MD Helicopters, LLC

***MD500/600 Series
Technical Bulletins Package***

This package contains a complete set of
all Technical Bulletins issued through:

22 August 2023

Figure 1. Installation - 369H90022 Anti-Ice Fuel Filter (Sheet 1 of 2)

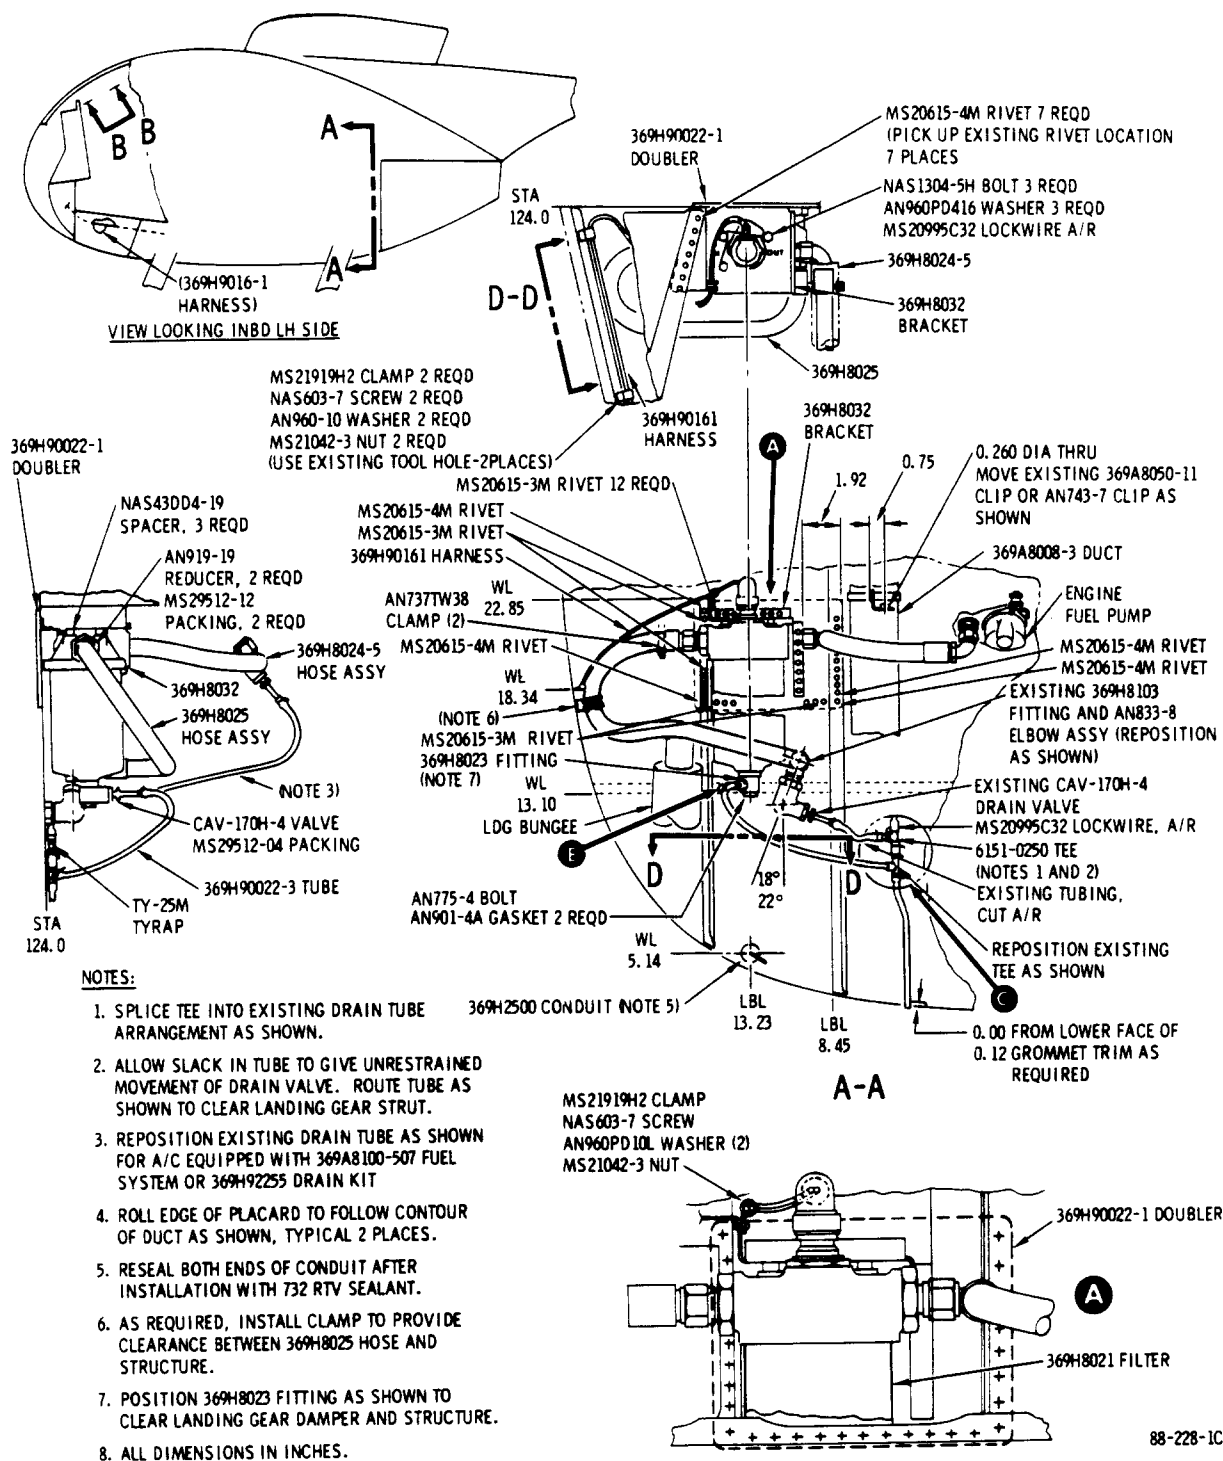
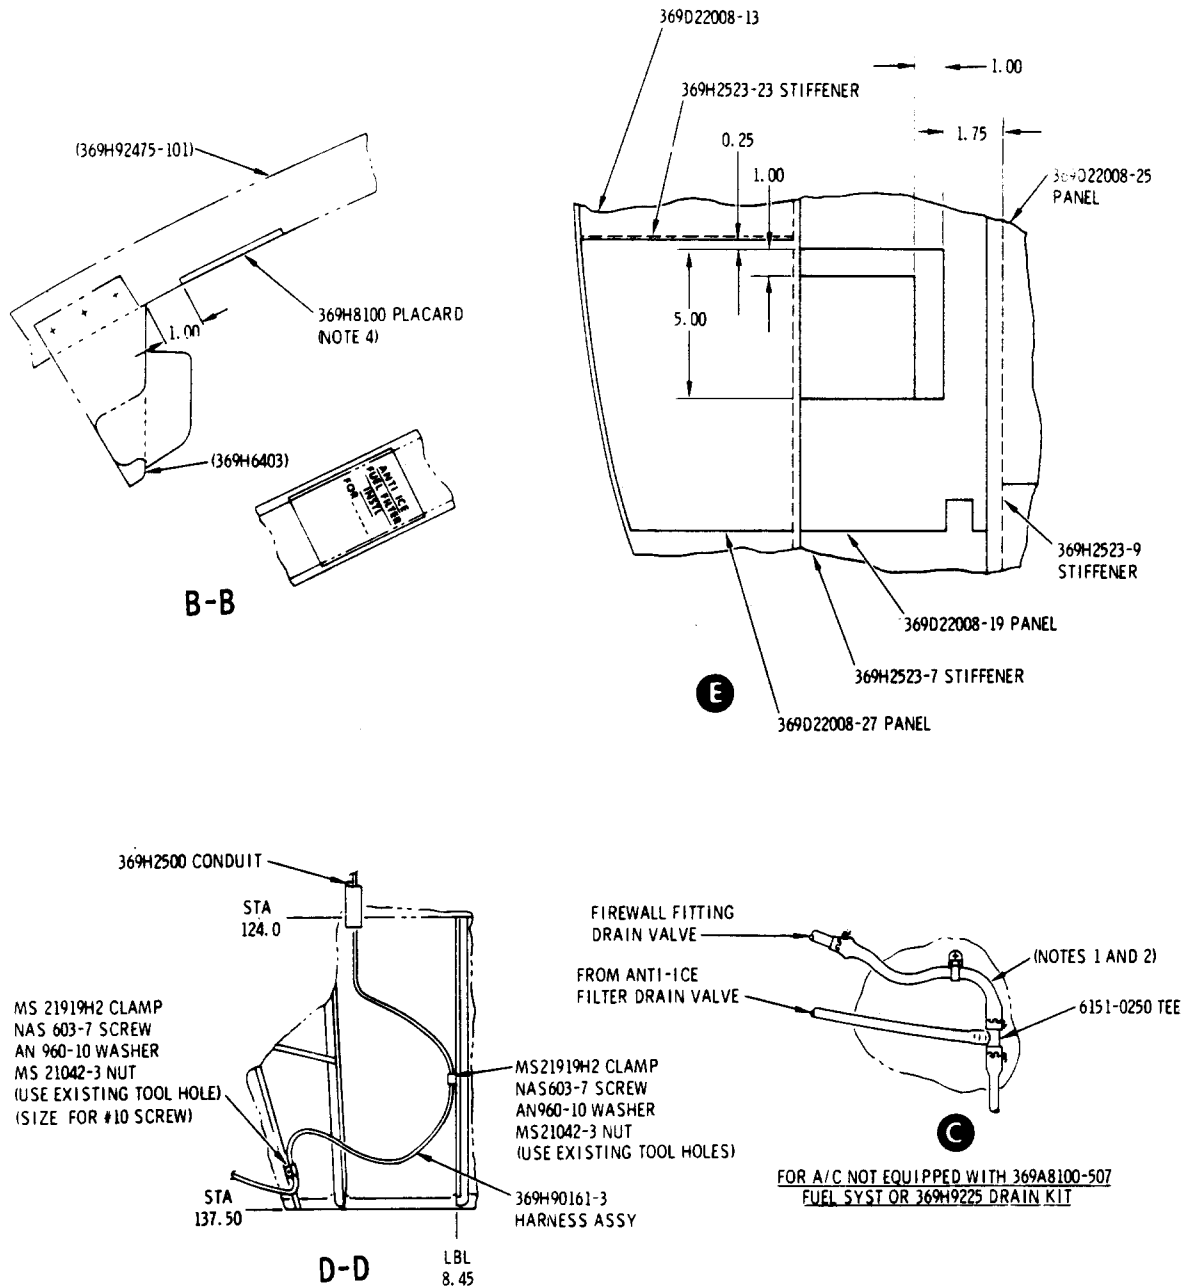
- (3). Using existing rivet pattern on Station 124.0 firewall, drill 0.1295-inch diameter holes and install 369A90022-1 doubler on FORWARD side of firewall as shown. Install rivets with zinc chromate primer. (View A-A and A, Figure 1.)

Figure 1. Installation of Stainless Steel Abrasion Tape,
 PN 369D21104, Main Rotor Blade Leading Edge

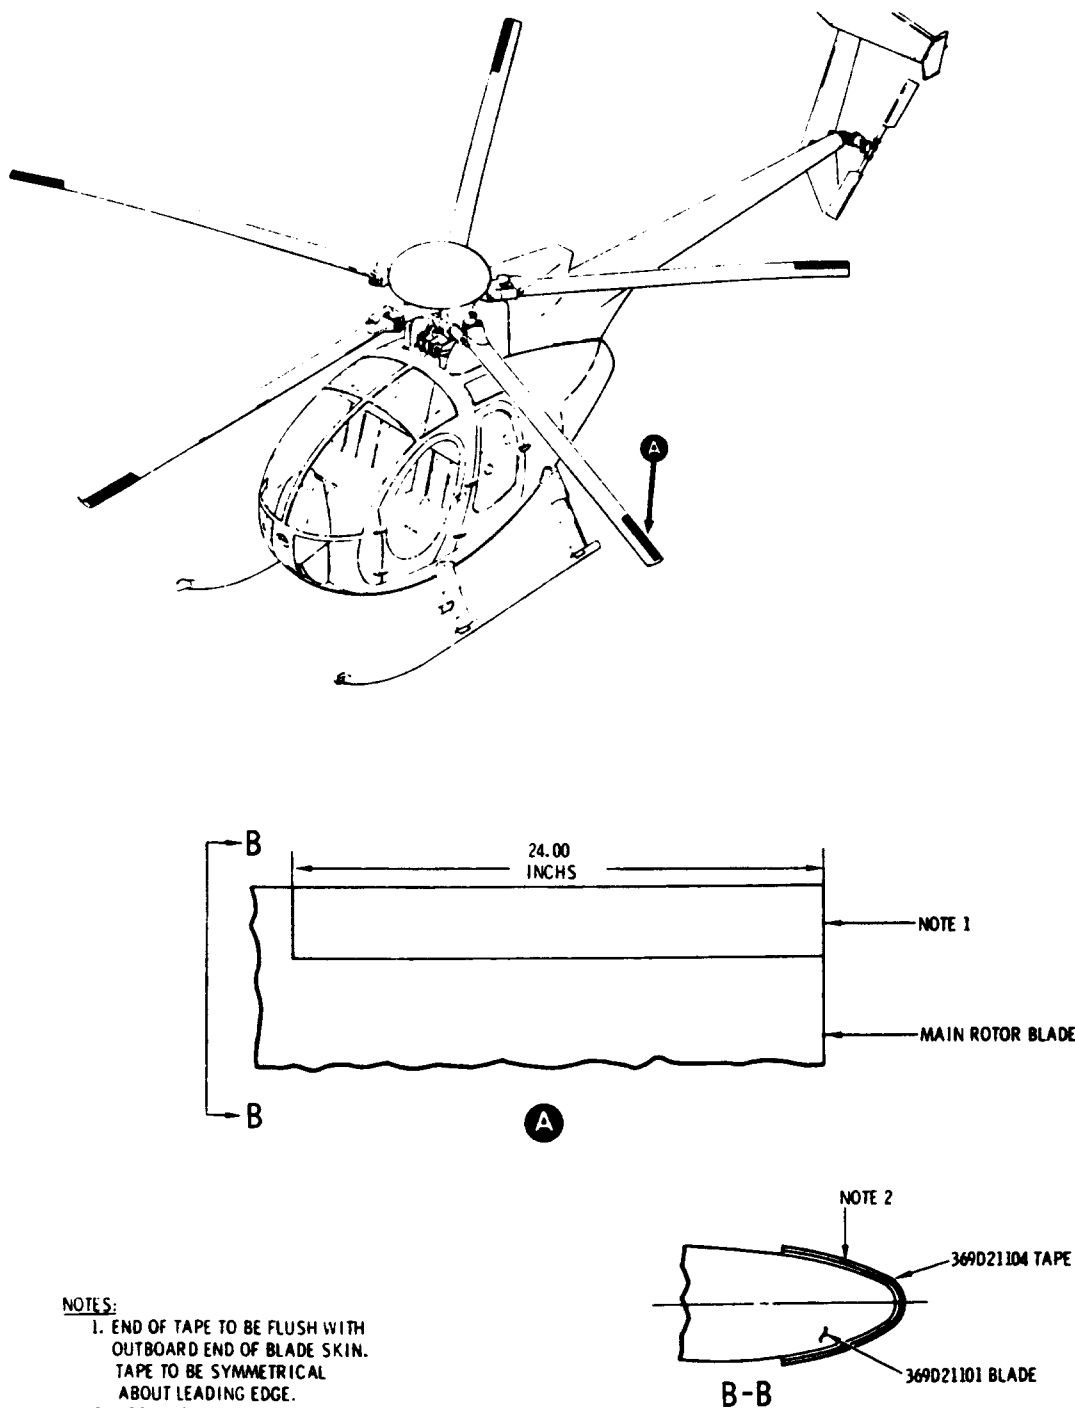
- a. Lightly abrade laying surface of main rotor blade with 400 grit abrasive paper. (See Figure 1.)
- b. Wipe faying surface of blade with solvent to eliminate grease or dirt film.
- c. Use heat gun or equivalent to warm blade laying surface; temperature is not to exceed 120°F.
- d. Remove backing and apply stainless steel abrasion tape to outboard leading edge of main rotor blade as follows:
 - 1). Apply the 6.50 inch wide and 24.00 inch long abrasion tape along blade leading edge, as shown, so that tape overlap over bottom and top of blade edge is equal.

Figure 2. Installation of Trim Actuator Assembly Access Panels

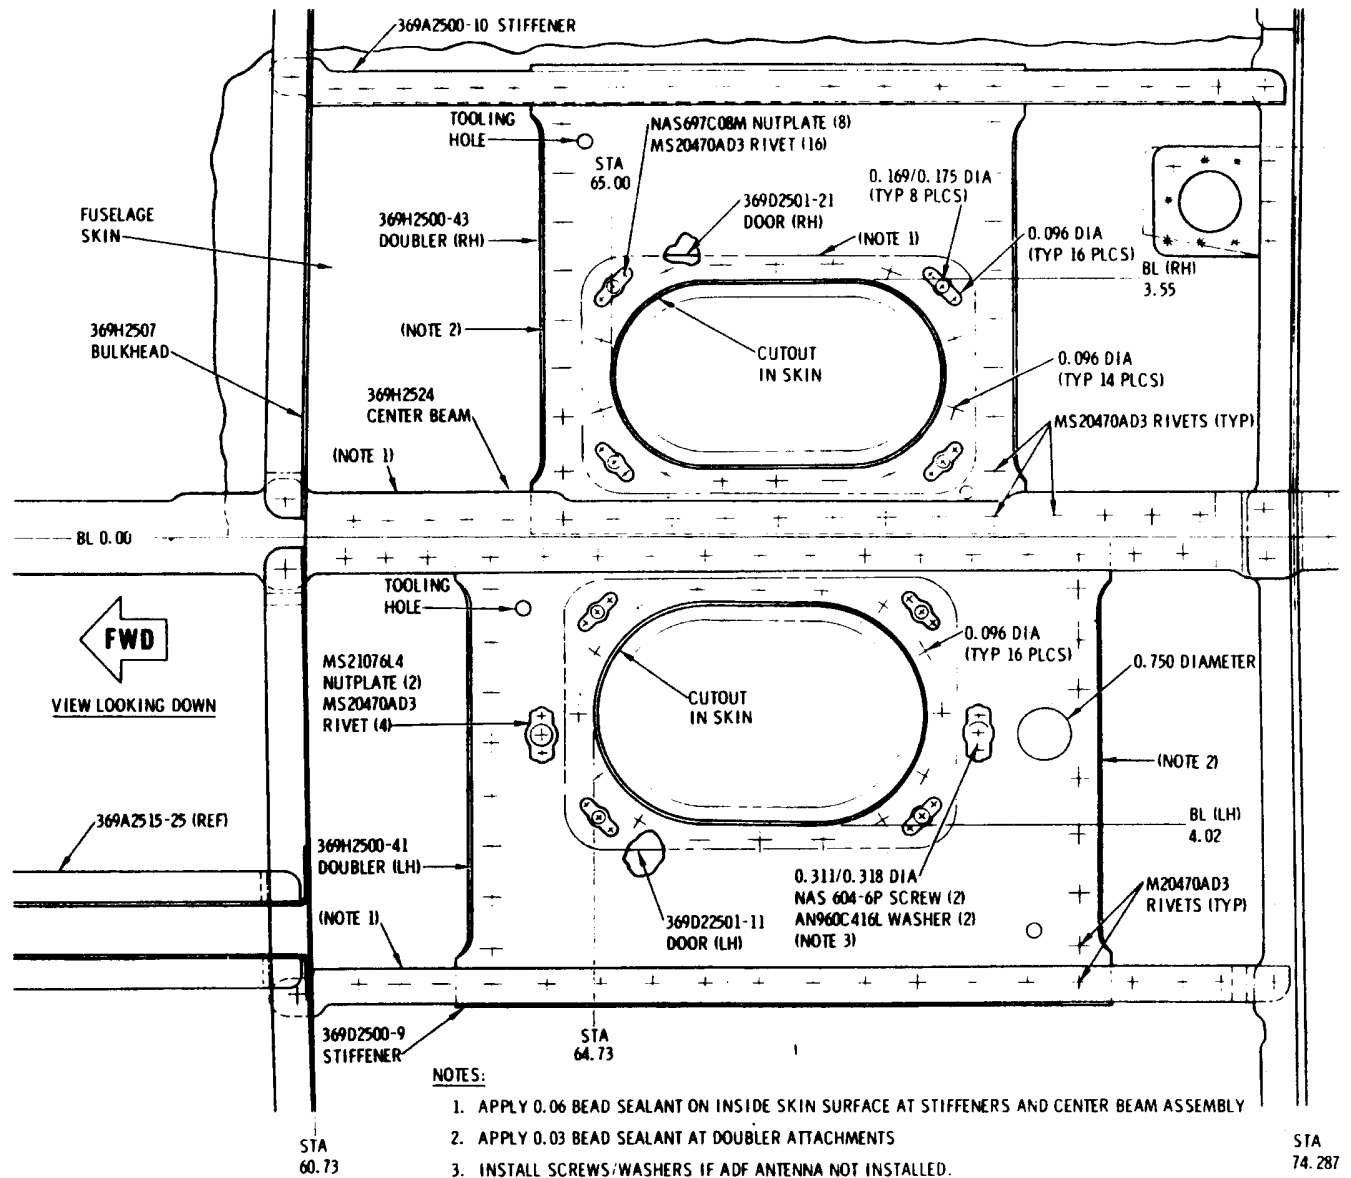
- c. Drill out rivets securing 369A2500-163 stiffener and 369A2500-169 doubler (see Figure 1). Drill out rivets securing 369A2500-164 stiffener and 369A2500-169 doubler. Drill out rivets securing 369A2500-165 doubler. Remove doublers and stiffeners; remove any sealing compound residue.
- d. Drill out rivets securing 369A2500-9 stiffeners, 369A2500-10 stiffener, and 369A2524 center beam assembly to fuselage skin between Station 60.73 and Station 74.287 as shown in Figure 2. Remove any sealing compound residue.

Figure 1. Installation of Fiberglass Cabin Heat Ducts,
 PN 369D22009-101 and -103 (Sheet 1 of 2)

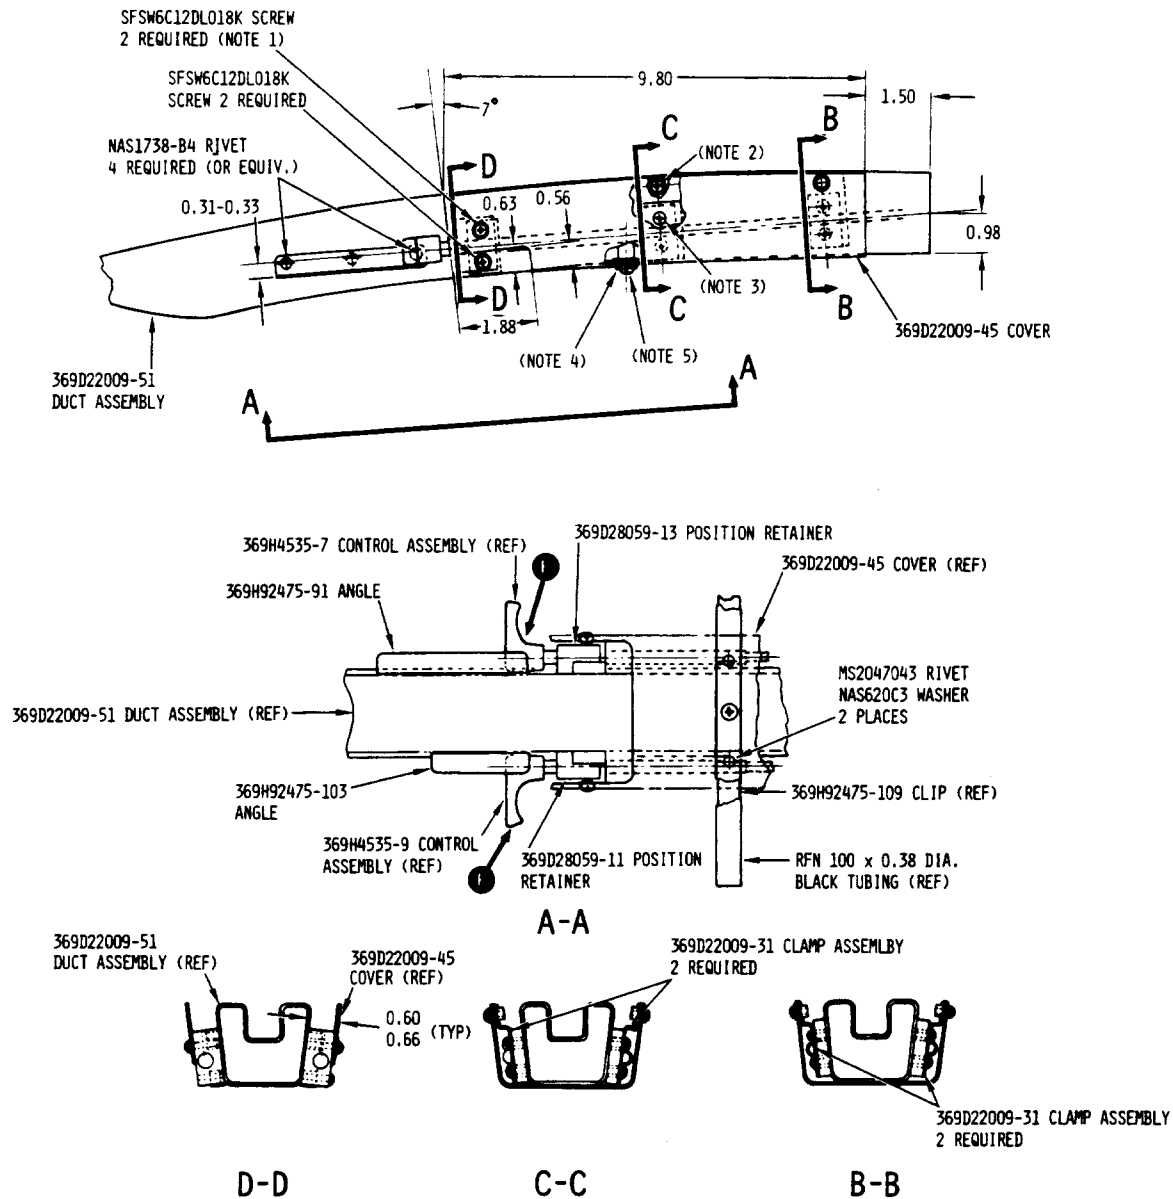
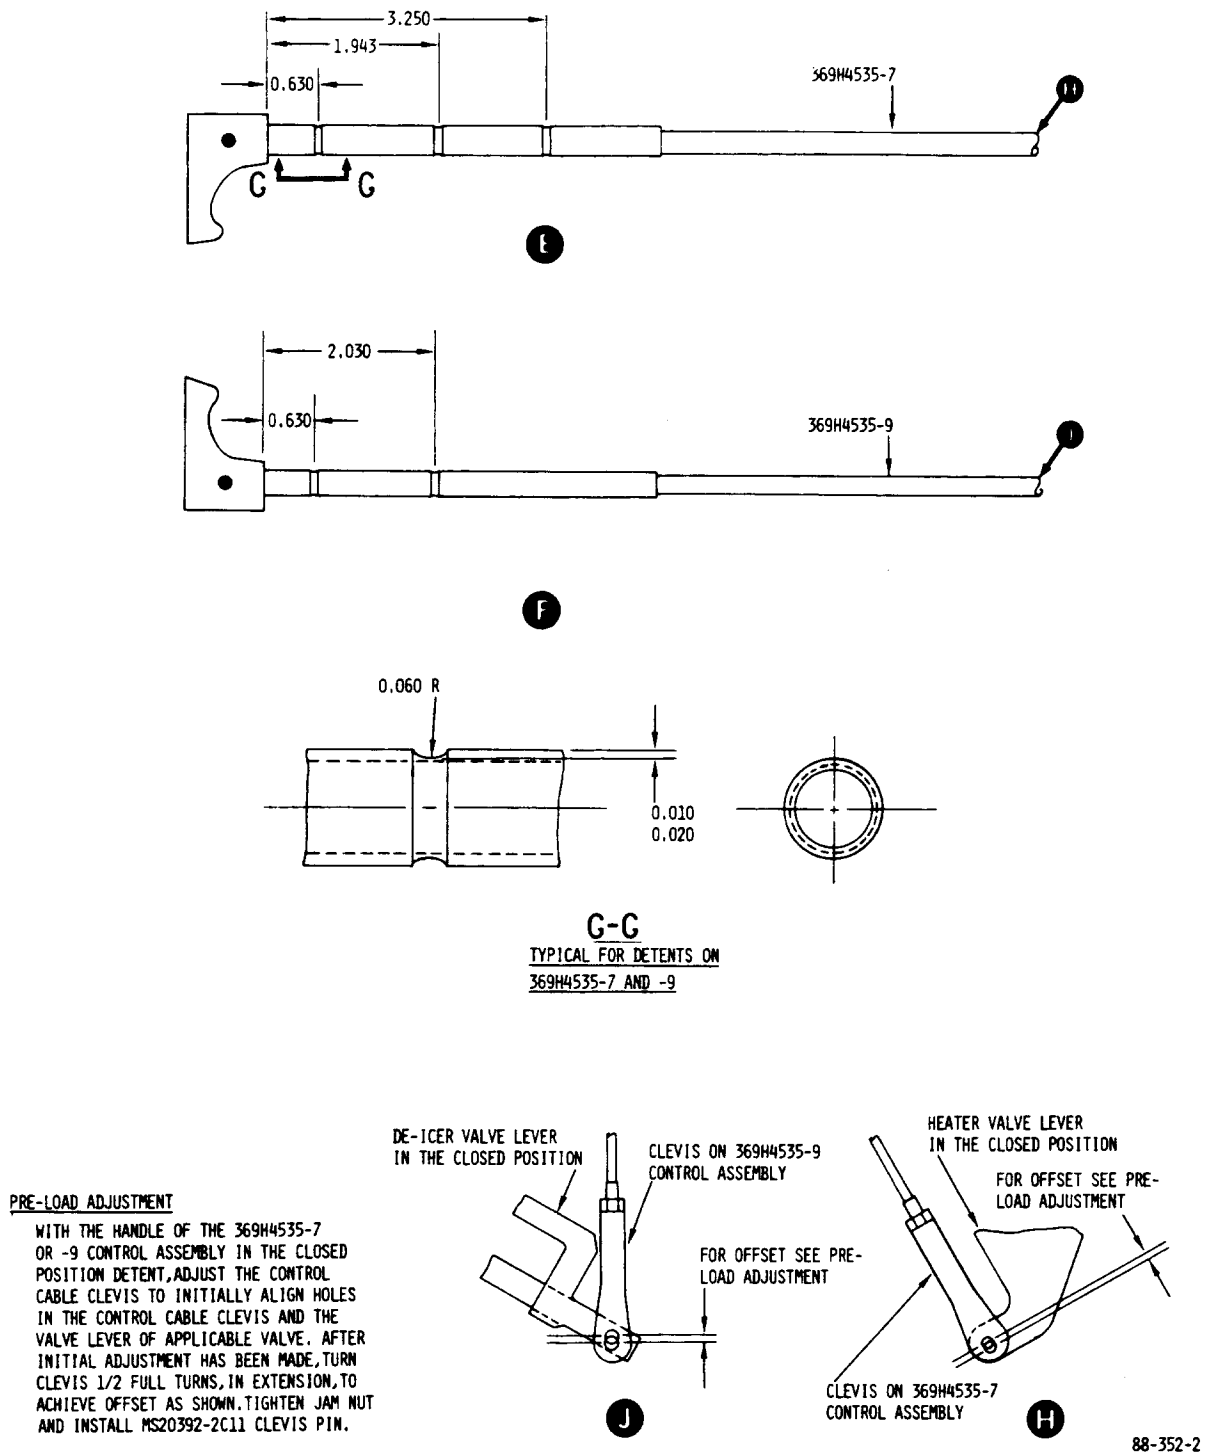
*369H4535-3 and 369H4535-5 control assemblies used with 369H92475-83 cabin heat duct assembly may be reworked to 369H4535-7 and -9 configurations required for use with new 369D22009-101 heating duct assembly. See Figure 1 for rework dimensions.

- a. Remove outer box from PN 369H92475-83 or -107 cabin heat duct and canopy frame. (Refer to referenced CSP-013.)
- b. Remove hardware securing heating and anti-ice control cable assemblies to heat duct; remove heat duct assembly. Remove existing PN 369H92475-31 or -101 cabin heat (lower) duct assembly. (See Figure 1.)

- h. Adjust preload of new PN 369H4535-7 and -9 control assemblies as follows: (See Figure 1.)
 - 1. Remove clevis from lever of applicable valve and loosen jam nut above clevis.
 - 2. With handle of 369H4535-7 or -9 control assembly in CLOSED position, adjust control cable clevis to initially align holes in clevis and valve lever.
 - 3. After initial adjustment has been made, turn clevis 1 to 2 turns, in extension, to achieve offset as shown.
 - 4. Tighten jam nut and install clevis pin.
- i. Perform operational check of heating system, per referenced CSP-013. Reinstall aft bulkhead access cover and interior trim.
- j. Perform operational check of anti-icing system, per Section 11 of Basic HMI-Volume I. Close plenum chamber access door.
- k. Install new PN 369D22009-45 cover with hardware as shown.
